# Addendum No. 7 to Contract Documents

Project	Biosolids Process Improvements	CWSRF Project No.	C7-6240-13-00
Owner	The City of Auburn		
Contract No.	BPI-1A General BPI-1B Heating and Ventilation BPI-1C Electrical BPI-1D Plumbing	Date	January 13, 2023

**January 13, 2023**

DRAWING NUMBER  
**D-30-103**

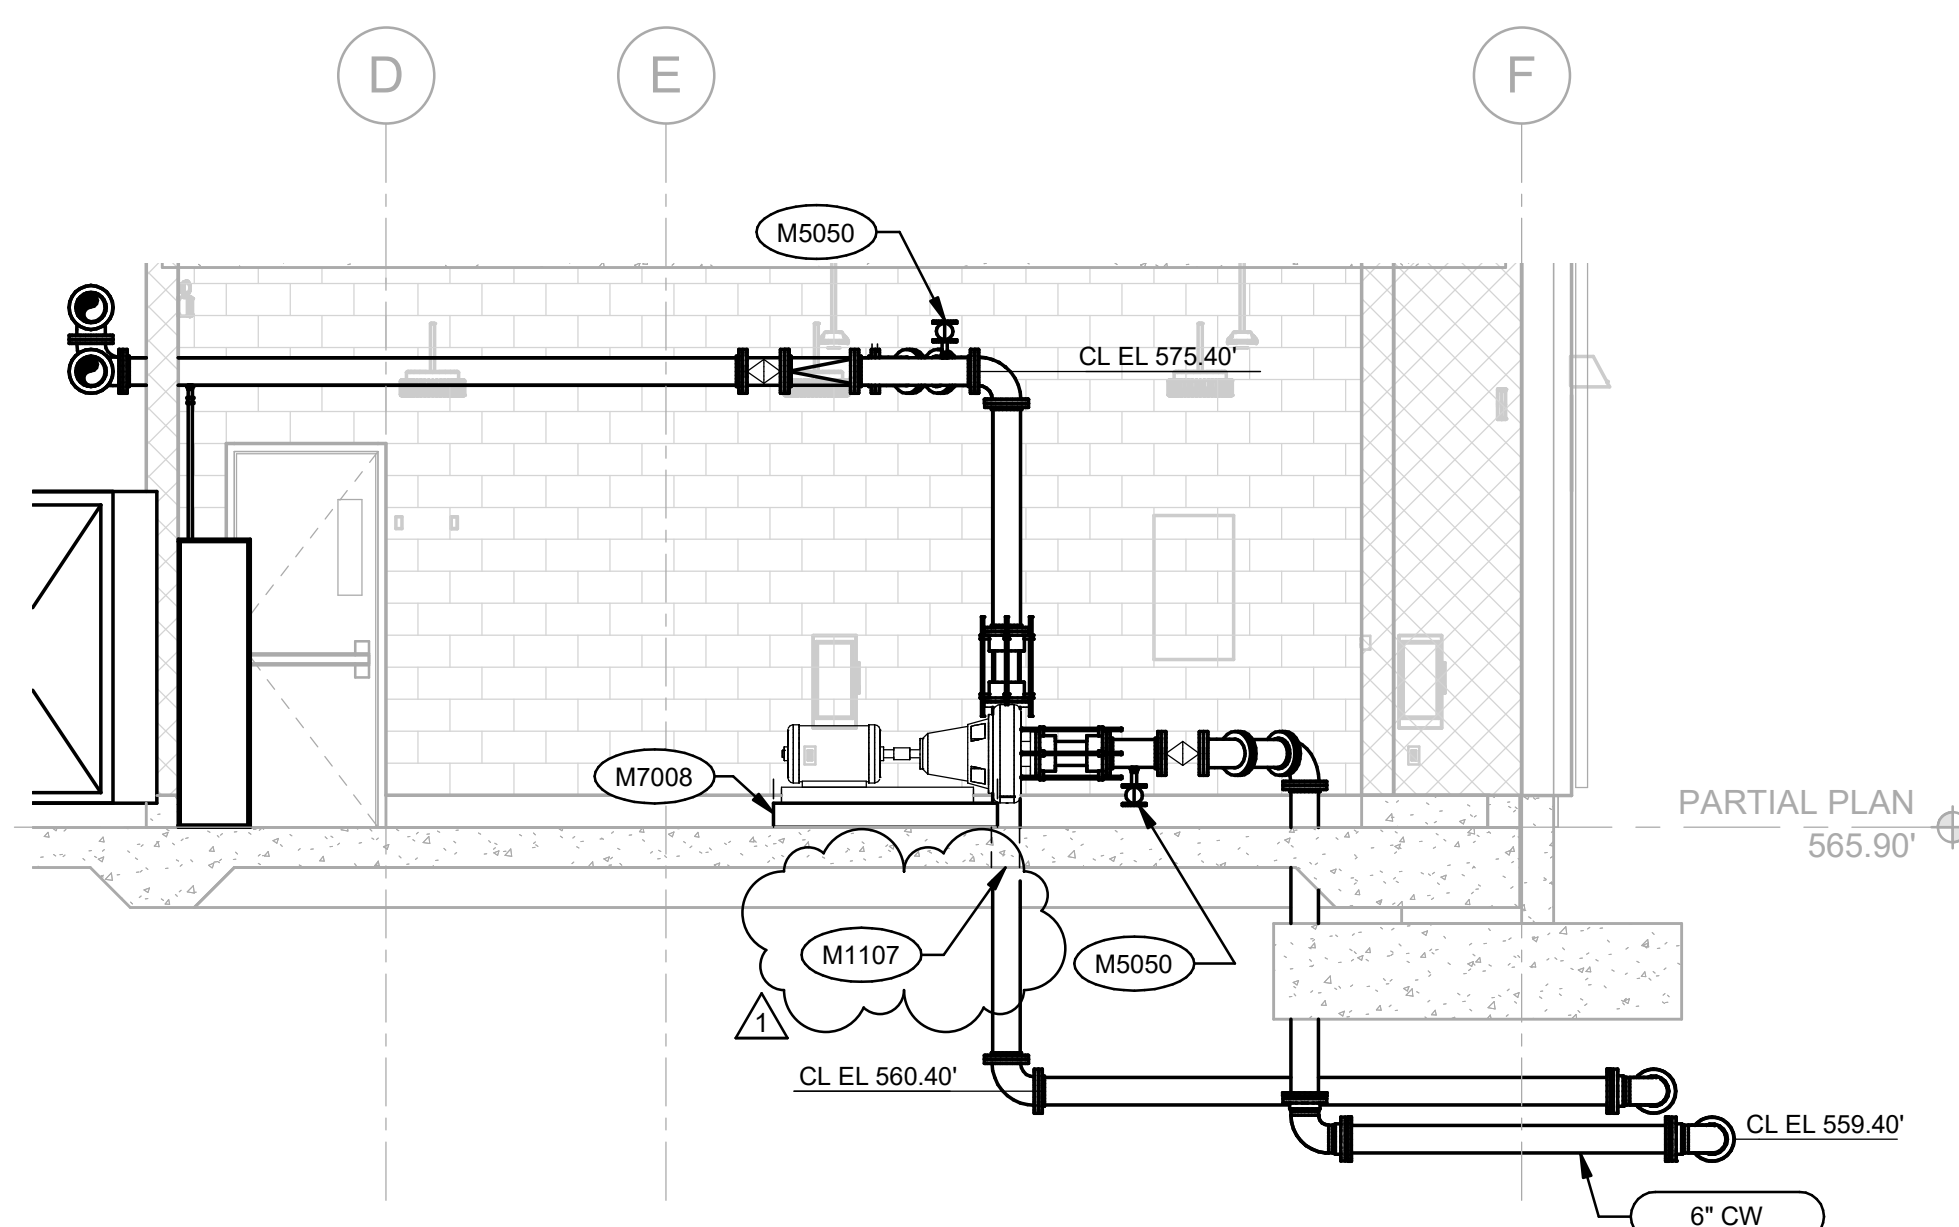
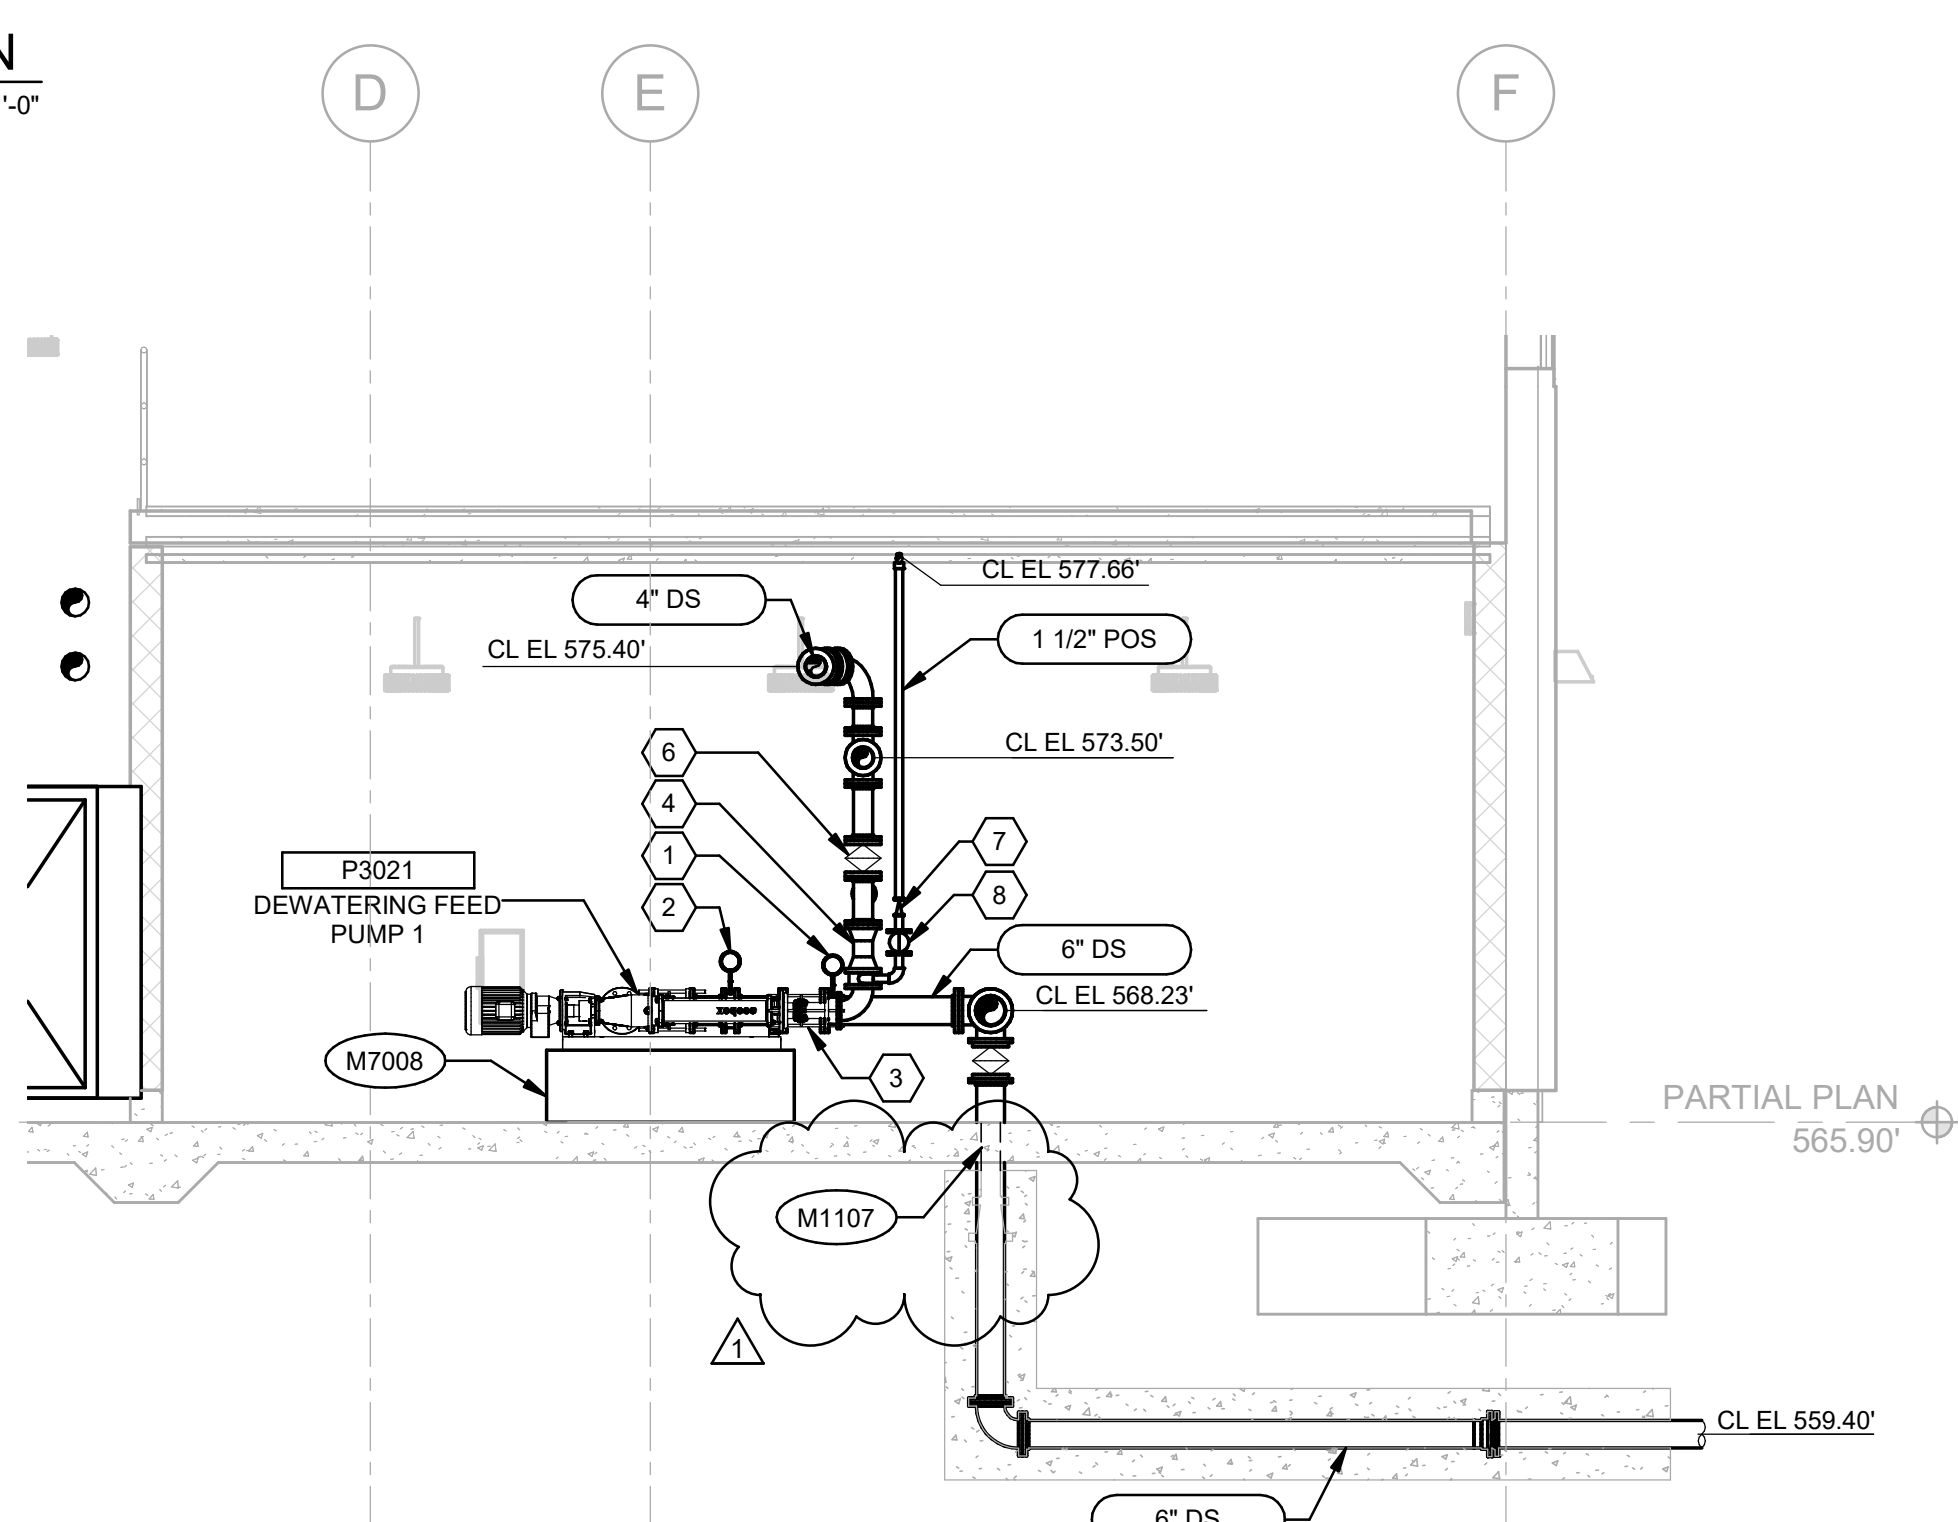
126	12/2/2022	M.A. Bongiovanni (Dennis Sexton)	D-30-301 and D-30-302 show a floor penetration detail of M1110. We do not find this detail number on D-00-002.	The callout should read Detail M1107	Yes	4	14
127	12/2/2022	M.A. Bongiovanni (Dennis Sexton)	D-30-102 references a detail M7005. We do not find a detail for M7005.	The callout should read Detail M005	Yes	4	14
128	12/2/2022	M.A. Bongiovanni (Dennis Sexton)	D-30-102 shows a plan view of the Cooling Tower. Can a detail be provided for the 6" CW supply and return piping connections for the Cooling Tower ? Will this exposed piping be heat traced and insulated ?	The sludge dryer vendor will supply the cooling tower and provide piping connection details. Exposed piping is to be heat traced and insulated.

296	12/16/2022	Ferguson Waterworks (Jeremy Suntken)	Dewatering and Dryer building series 30 drawings call out for the pipe penetrations through the slab to be M1110. Detail M1110 was not located on drawing D-00-002 or any other process drawing. Please provide additional information for penetration M1110 requirements.	See question #126			
297	12/16/2022	Ferguson Waterworks (Jeremy Suntken)	Drawing D-30-301, section 3 appears to show the 6" DS line to be flanged where almost the end of the encasement, then transitions to restrained joint pipe. Please confirm the spool through the slab, and the 90-degree bend, connecting spool that are encased are to be flanged.	See question #126, joints are to be flanged			
298	12/16/2022	Ferguson Waterworks (Jeremy Suntken)	8" Filtrate line in the Dewatering and Dryer Building appears to start flush with the slab below the Belt Presses on drawing D-30-303 section 5. Please clarify the starting point for the Filtrate line is flush with the top of the slab or provide additional information. Please also clarify the type of penetration required through the slab.	Yes the starting point for the filtrate line is flush with the sump under the belt filter press units to collect the filtrate that falls into the sump. Follow Detail M1100 on sheet D-00-002 for penetration types.
